**25RFP007 CMAR BSL-3 Lab Construction Reissued
Addendum #1 Revision to Section III and Q&A
Issued: 02/06/2025 (Revised 02/11/2025)**

Questions and Answers

Q2-10 Figure 1

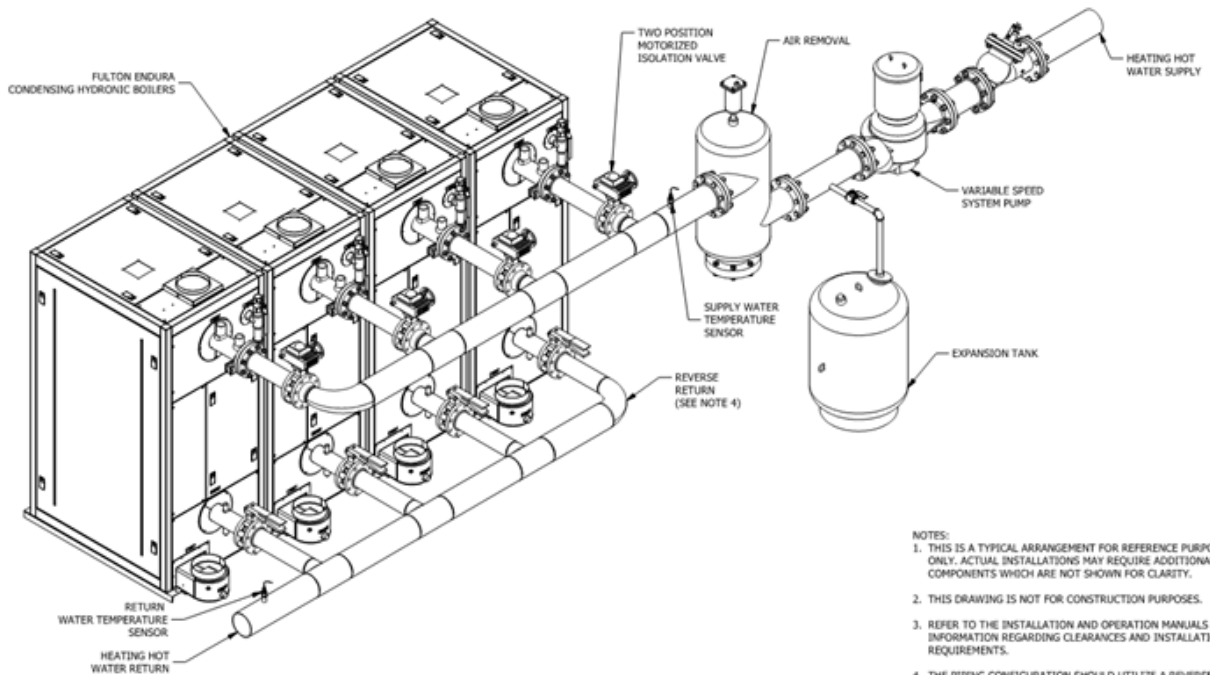
Q2-9b	01/27/2025 2:31 PM	Does the 14 month construction schedule include phase 1 and phase 2?	<i>Just Phase 1.</i>
Q2-9c	01/27/2025 2:31 PM	Will 25RFP007 be for phase 1 and phase 2 combined?	<i>It combines Phases 1 and 2 as reflected in the Plans.</i>
Q2-10	01/31/2025 10:04 AM	RM-RFI-1 - Sheet HP2.1.1A shows the installation of one Chiller (CH-1) and two Boilers (B-1 & B-2) in the Mechanical Yard. Detail sheets H6.1 and H6.2 do not include a Chiller Connection Detail or a Boiler Connection Detail. Can you please provide a Chiller Connection detail and Boiler Connection detail showing all piping accessories that are to be included for the installation of this equipment?	<i>Chiller shall be set on restrained spring vibration isolation. Therefore, flexible connections to the chiller will be required. Please refer to manufacturer installation requirements. Attached Figure 1 Q2-10 is from the basis of design chiller manufacturer and is provided for reference and specifications. See Attached Figure 1 Q2-10.</i> <i>Connect hot-water piping to supply- and return-boiler tappings with flexible connection, shutoff valve and union or flange at each connection. In addition, provide pressure gauge, test well, temperature gauge, 2-position isolation valves for each boiler. Refer to manufacturer recommended pipe installation as shown in the attached Figure 2 Q2-10 for reference.</i>
